**FALCON HIGHLANDS
LETTER OF INTENT
SKETCH PLAN MAJOR AMENDMENT**

March 15, 2022

LOI_V3 comment.pdf Markup Summary 4-7-2022

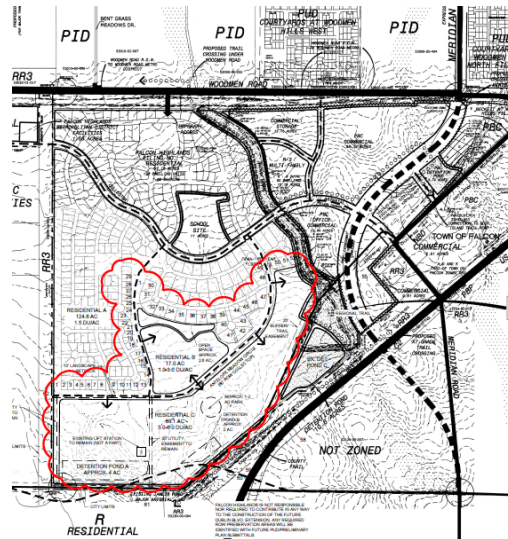
State why this qualifies for an administrative minor SKP amendment approval. It is only X percent of the larger skp, adding x open-space then what was previously approved; less than 25% of the overall density of the SKP etc
